SUNDRY NOTICES AND REPORTS ON WELLS

Myers Langlie Mattix Unit

30-025-25988

OXY USA WTP LP
Myers Langlie Mattix Unit #48
API No. 30-025-25988

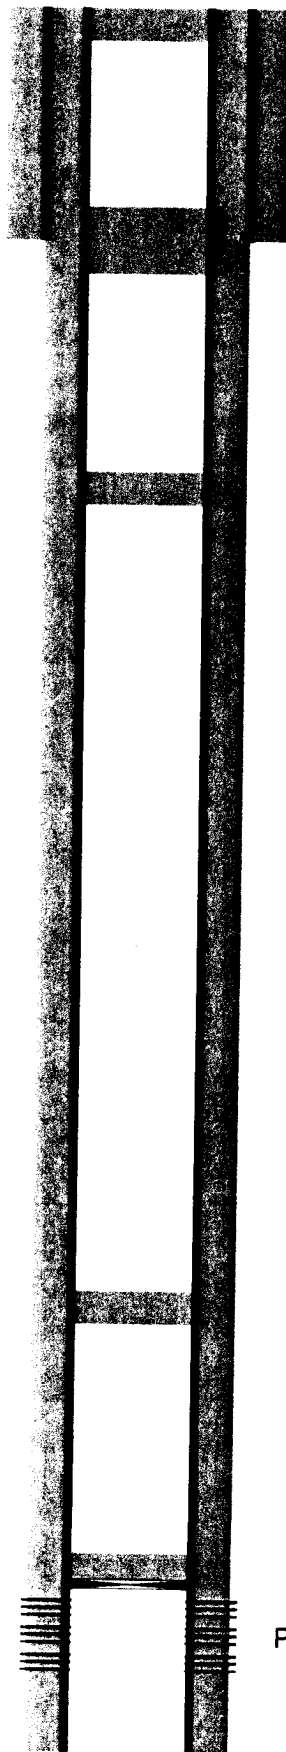
1. Approval is granted to plug this well with the following modifications to the proposed procedure:
2. All plugs below the surface plug should be tagged for casing shoes and the top and base of the salt.

***** All plugs below the surface plug must be at least 100' and 25 sacks of cement.**
